Subject: Oakfield Wind Project, Aroostook County, Maine
MDEP# L-24572-24-A-N; IL-24572-TF-B-N

Attached for filing is supplemental information for the above referenced application for the Oakfield Wind Project. As previously discussed, this filing updates seasonal vernal pool and rare plant work; provides the results of a recent site visit with Norm Dube of DMR and LeeAnn Neal of the Corps; includes an addendum to Section 30, the visual impact analysis; and submits an errata to the Section 5 sound report.

Significant Vernal Pool 04ma

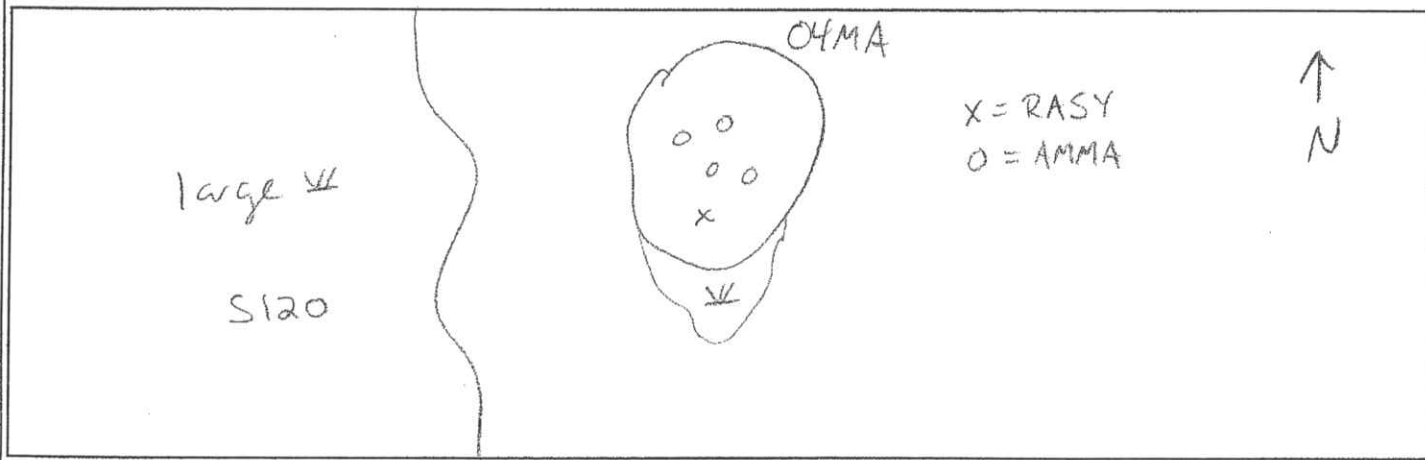
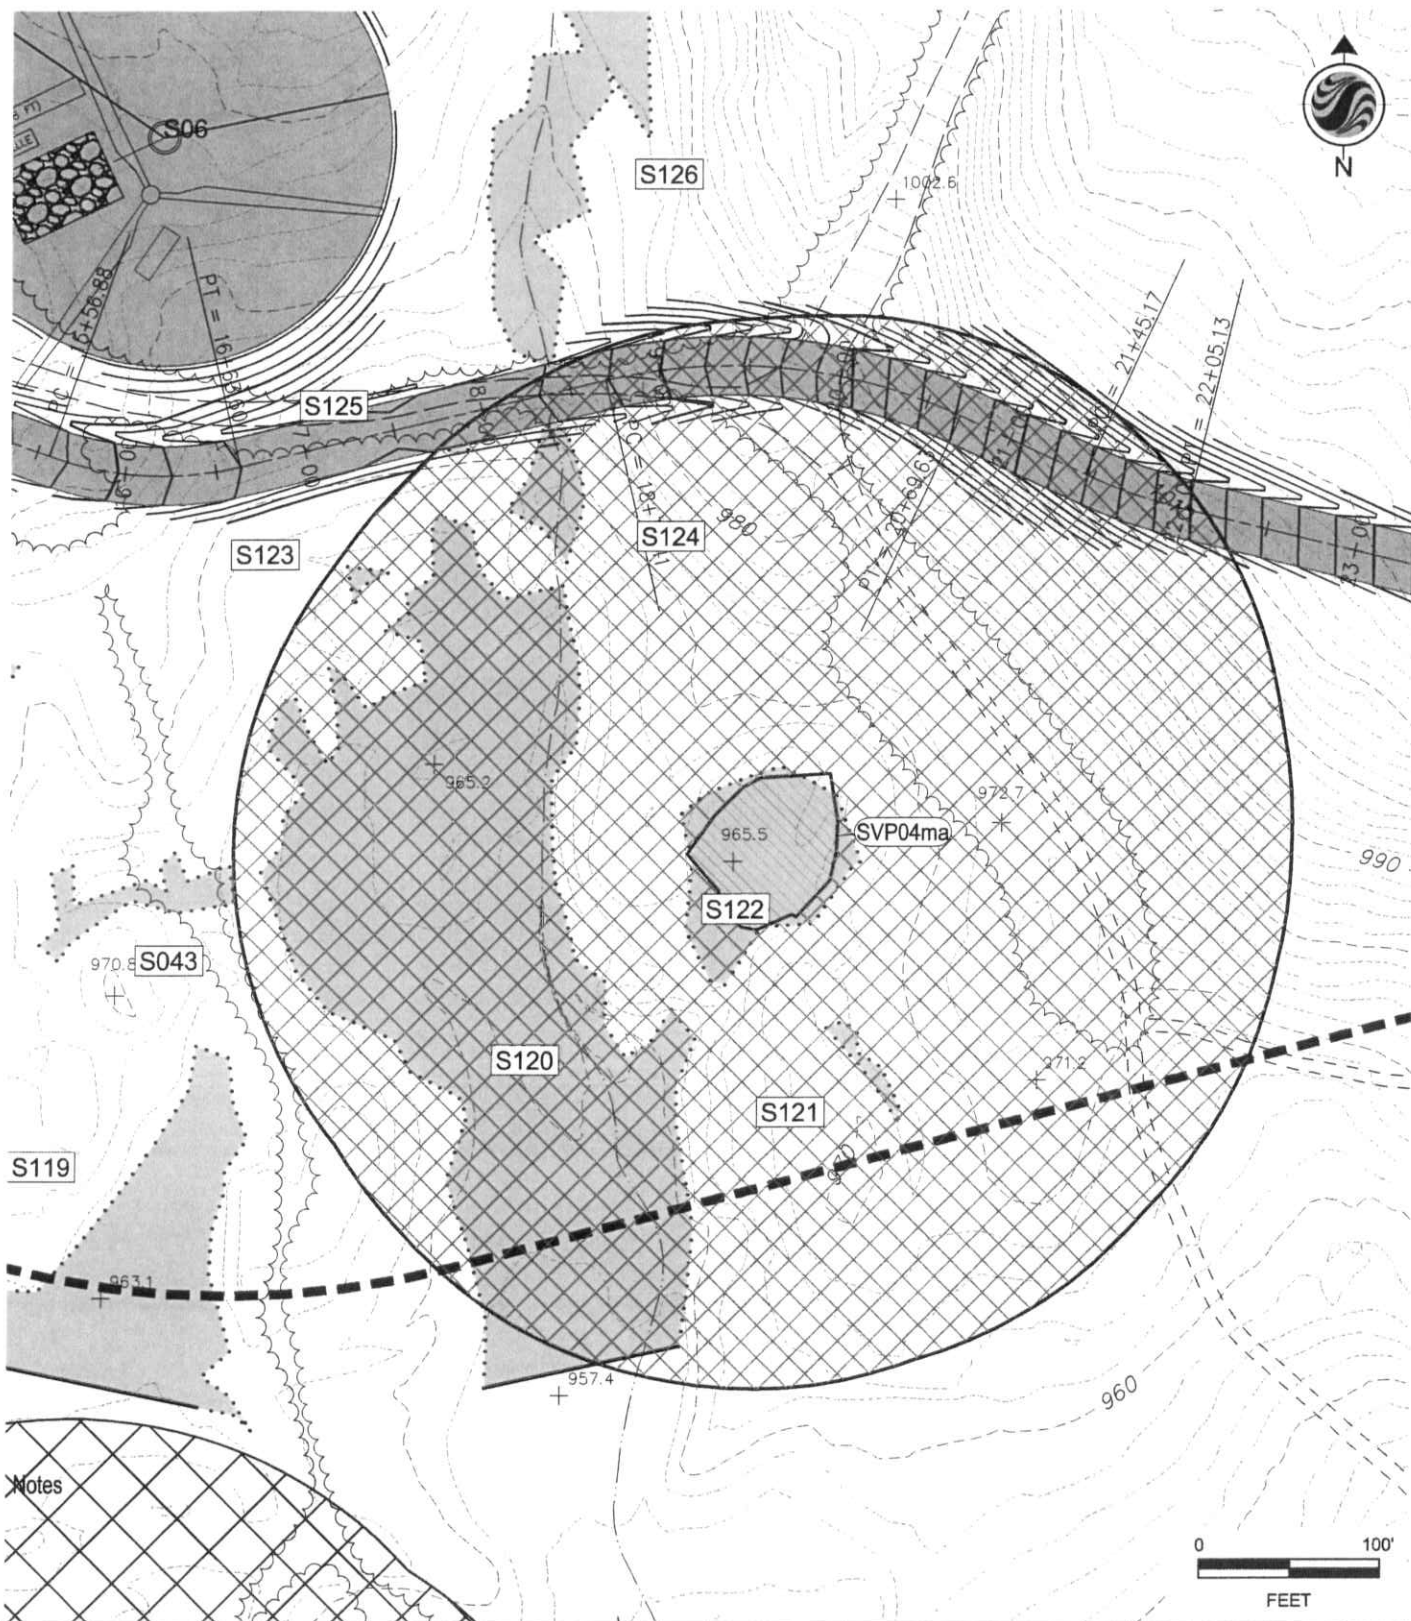
Figure 1 illustrates the significant vernal pool habitat impacts caused by the crane road in this location. The project was designed with an assumption that this might be a significant vernal pool. The road crosses the drainage where wetland impact will be minimized, and swings slightly north to bend away from the pool. Due to the steepness to the north, any further movement in that direction would increase the grade above 10% and result in substantially more cut and fill. With this effort at minimization, new disturbance is limited to 6% of the significant vernal pool habitat. The total impact for old and new activity is 18% of the total habitat; 82% remains undisturbed.

Photos taken by LeeAnn Neal, ACOE, during a June 11, 2009 site visit

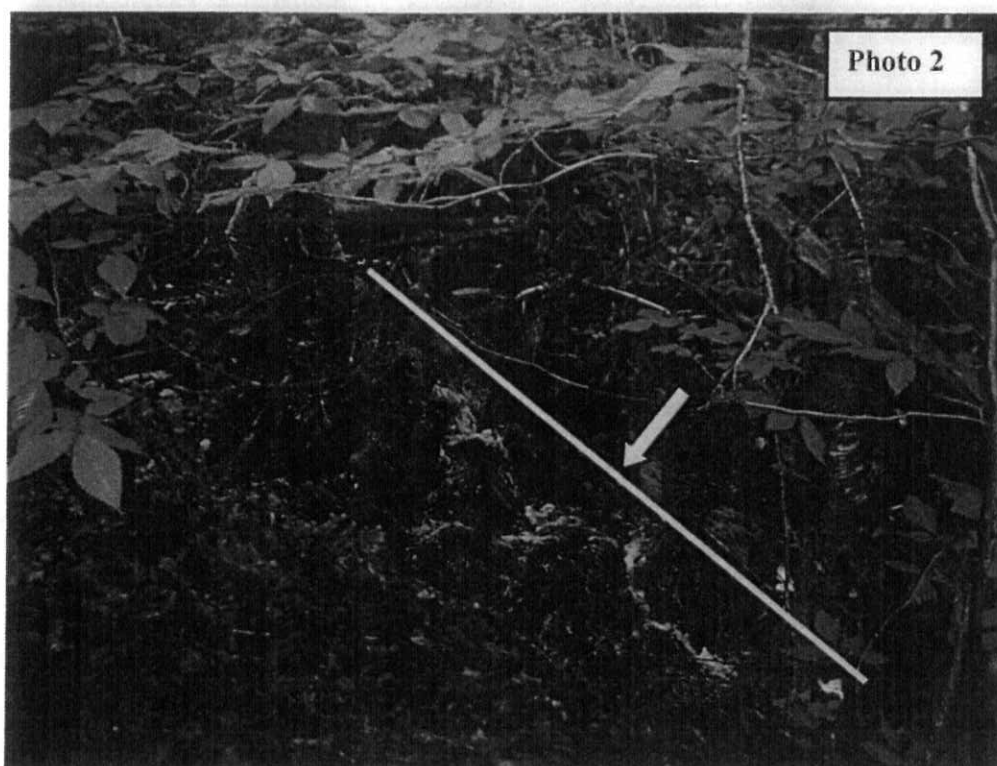
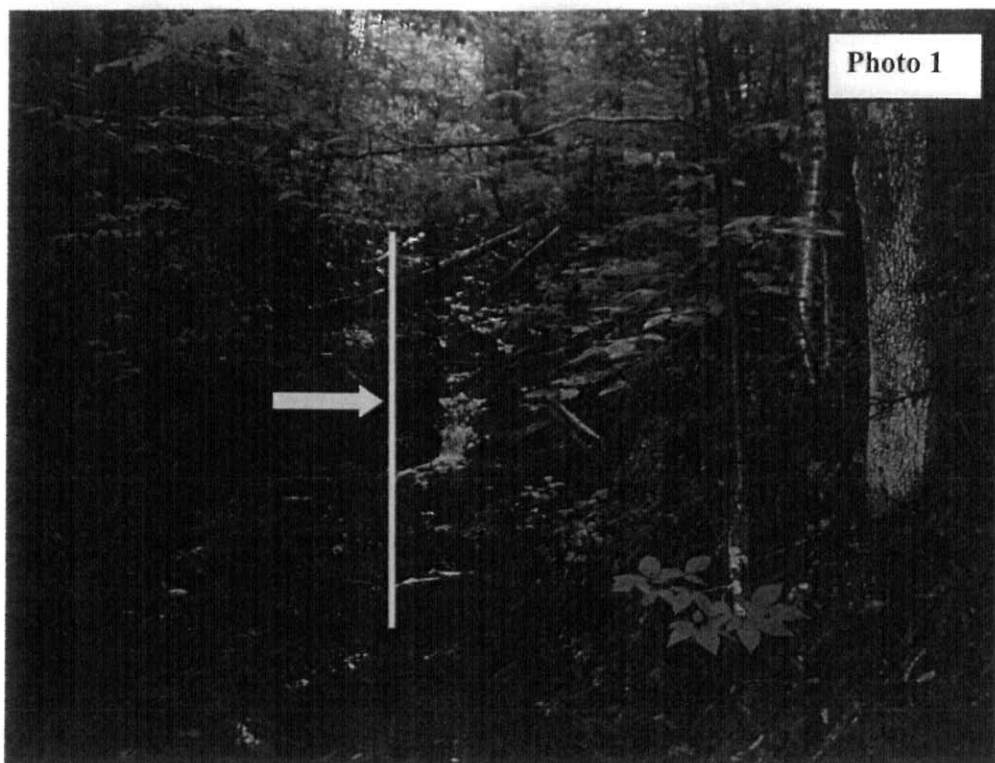
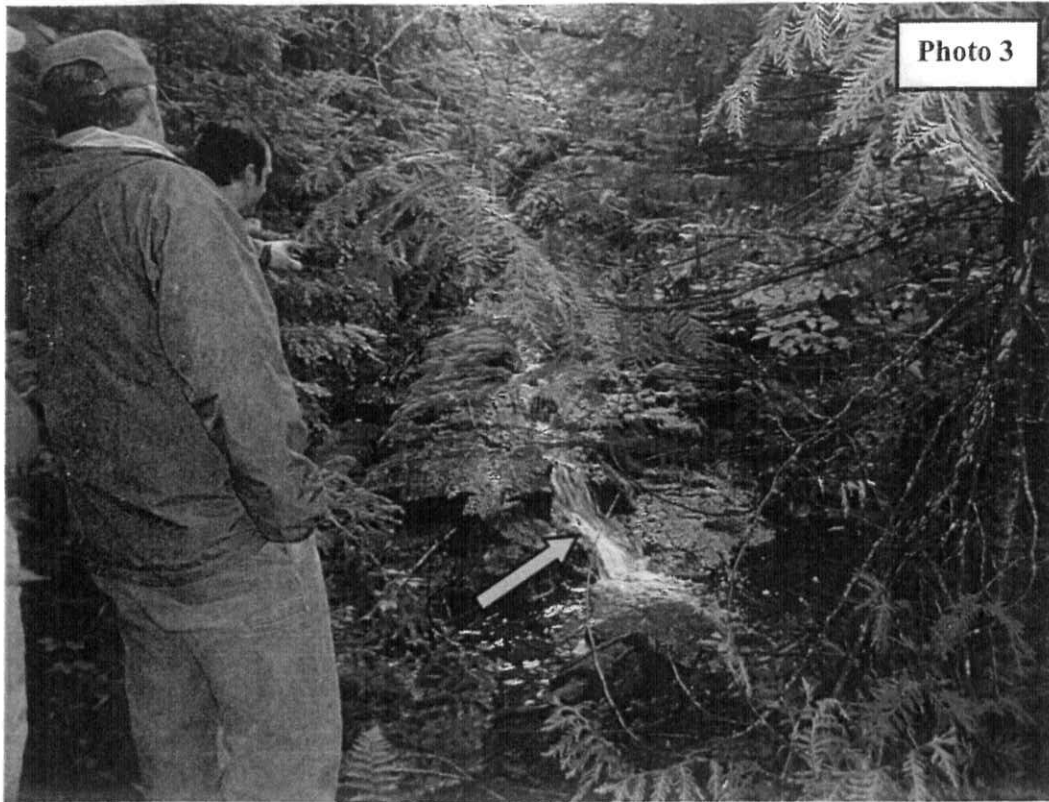
On June 11, 2009, Brooke Barnes (Stantec), LeeAnn Neal (ACOE), Norm Dube (DMR), and two First Wind employees walked several sections of the brook downstream of and up to a proposed road-stream crossing. In question are whether two cascades prevent adult and/or juvenile Atlantic salmon from migrating above the cascades into suitable habitat where the road-stream crossing is proposed to be located.

In my opinion, it is extremely unlikely that adult Atlantic salmon would be found in this stretch of the brook since the size of the brook is not conducive to adult Atlantic salmon movements. Discharge in the brook would be higher in the fall at the time of spawning; however, spawning habitat and holding pools were not observed.

The brook does contain habitat that could support juvenile Atlantic salmon. It is conceivable that juvenile Atlantic salmon could enter into the brook (e.g from the East Branch where salmon are stocked) and swim as far up as the cascades. Four photos in the attached PDF file illustrate the cascades. It is my opinion that, at the observed discharge, it is unlikely that juvenile Atlantic salmon could surmount the cascades since flow is quite laminar making it difficult for salmon to swim up through this flow field for any length. There were no pockets for fish to jump into and from should salmon attempt to surmount the cascades. Higher discharges would make any attempts to swim up through even more difficult.
